Arlington Zoning Board of Appeals

Date: Tuesday, January 9, 2024

2. Docket #3764 212 Pleasant Street (continuance)
3. Docket #3776 49 Dickson Ave
4. Docket #3777 95 George Street

Re: Revised Application for Special Permit – 212 Pleasant Street

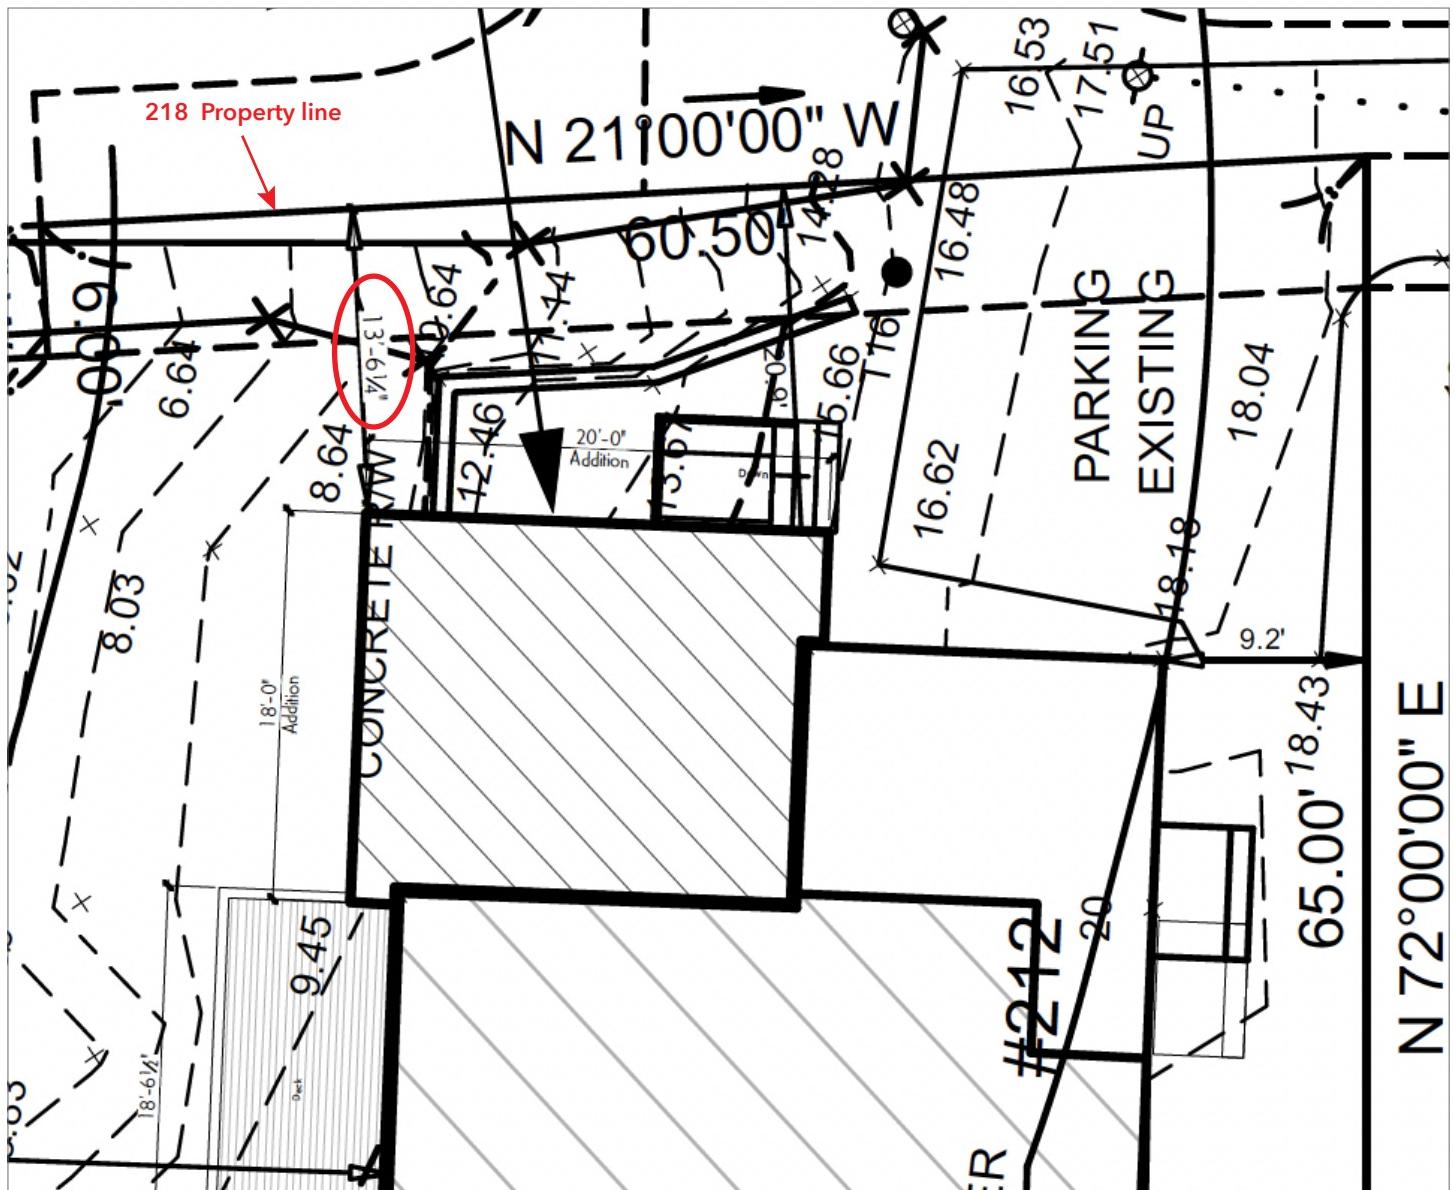
We would like to see the plans for how they are changing the parking area at 212 Pleasant Street. We cannot tell from the existing and proposed plans how it is being enlarged from 480 square feet to 638 square feet. We find this square footage only on calculations of open space but not on plot plans (Attachment B). We have had a survey done and we want to know the bigger parking area is not on our property or blocking 216 Pleasant's easement. We also want to understand what changes to the land will have to be made to make room for the much larger parking space. We are concerned that the applicant cut down a protected tree to create more space. Another worry is how changing the parking area with permeable materials could impact our home. We want an engineer to review complete plans so we are not worried about the water in the ground damaging our property and foundation.

In the architect's plans, the large addition will have a side porch and steps off the right of the house. We are not sure whether they meet the minimum yard requirements in the bylaw (5.3.9. Projections into Minimum Yards). There are no dimensions for the porch and steps provided in the drawing but it looks like the porch will go out about 5' and including the steps, about 7.5' from the house. We see what might be the side porch on the proposed plot plan but not the steps that go towards our property line. See Attachment C. We would like a clear drawing and measurement to know whether the porch and steps go into the 10' setback required from our property line, and if so, whether they meet regulations.

Drawing C1.1 Proposed Site Plan submitted by Applicant (magnified)

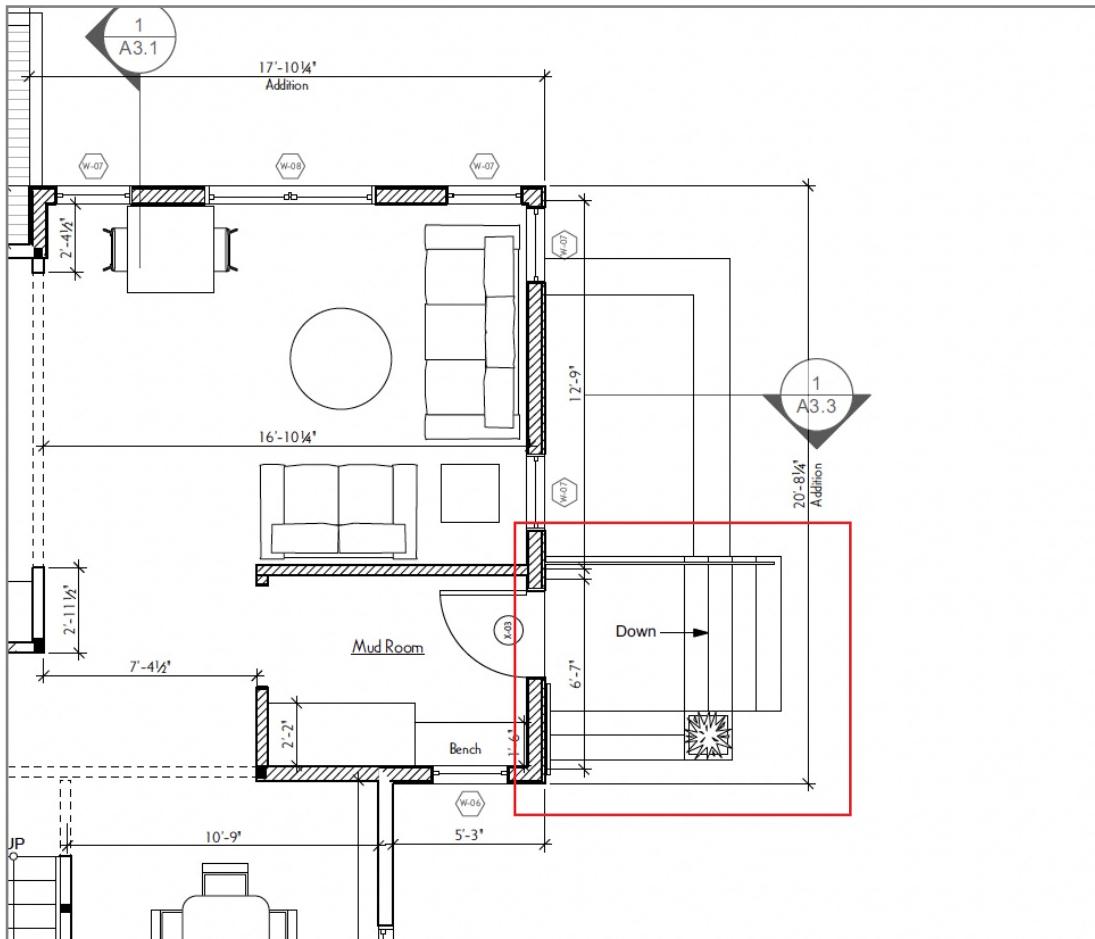
What is proposed parking?

Drawing C1.1 Proposed Site Plan submitted by Applicant (magnified)

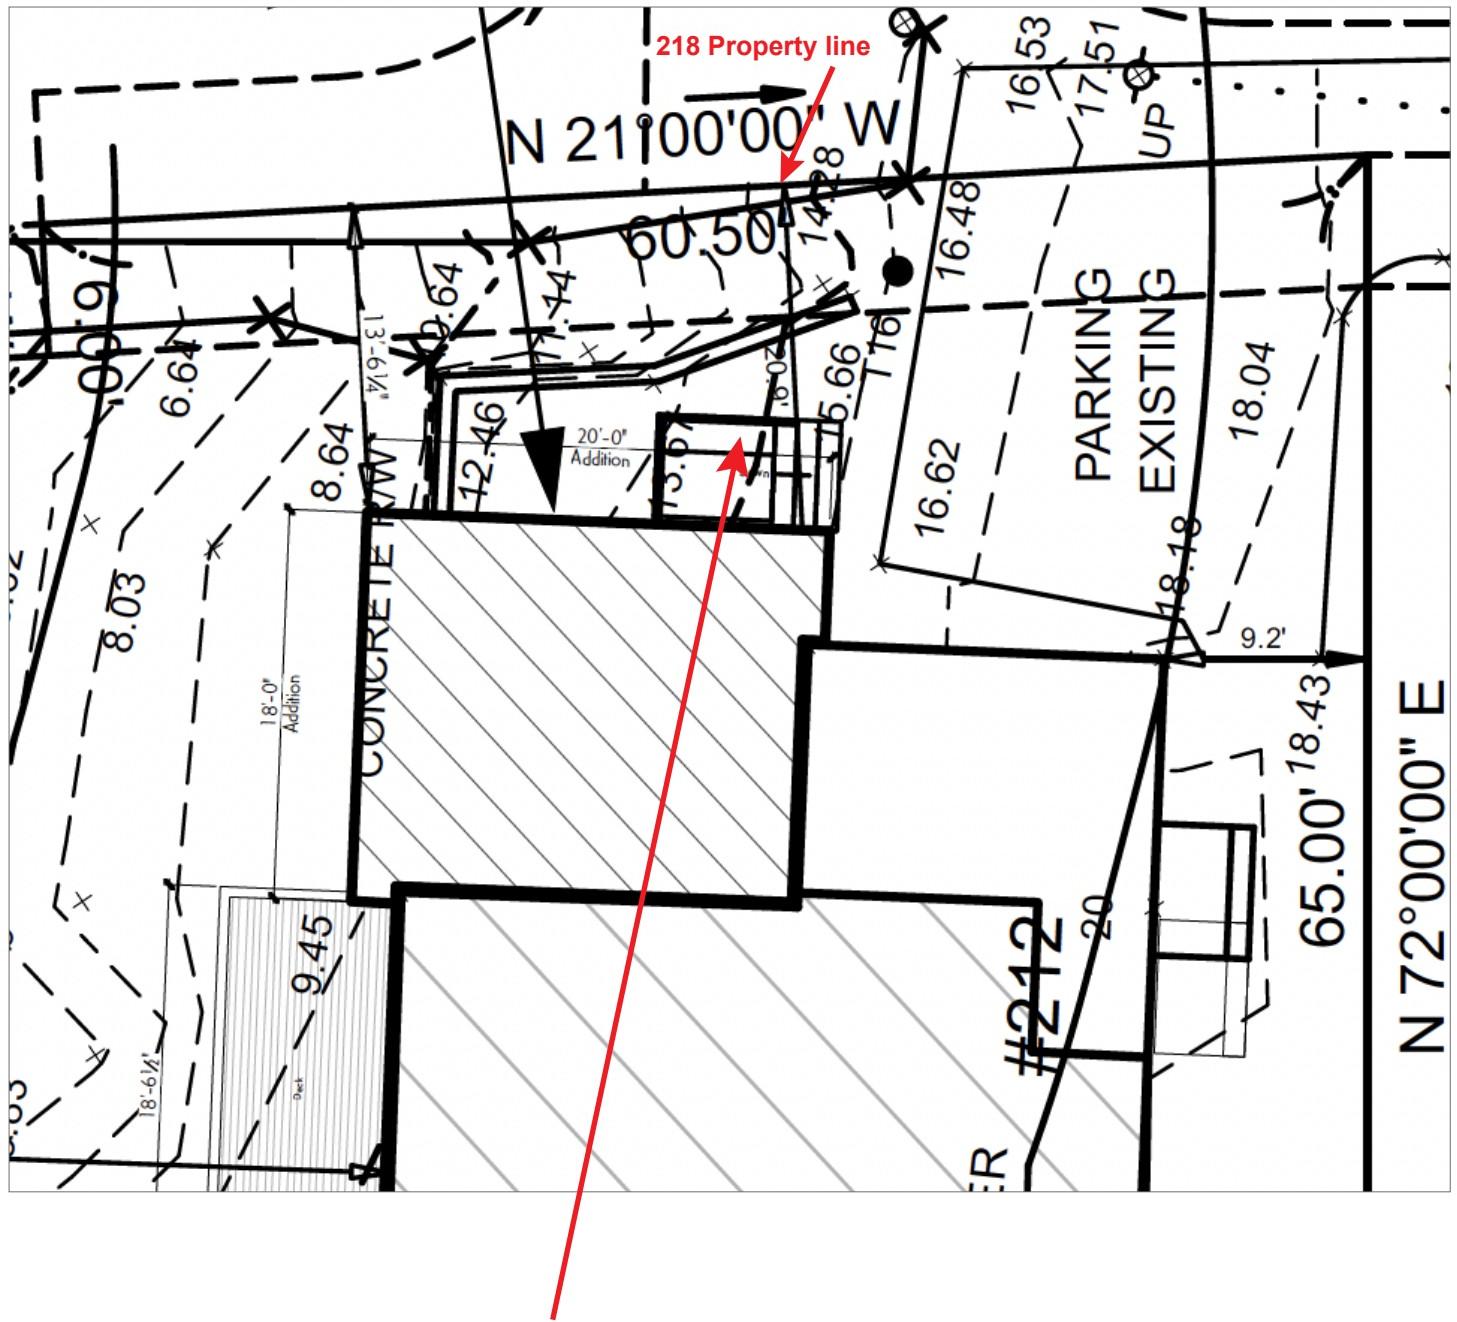
Is this drawing of side porch? Does it include steps going out towards 218's property line?
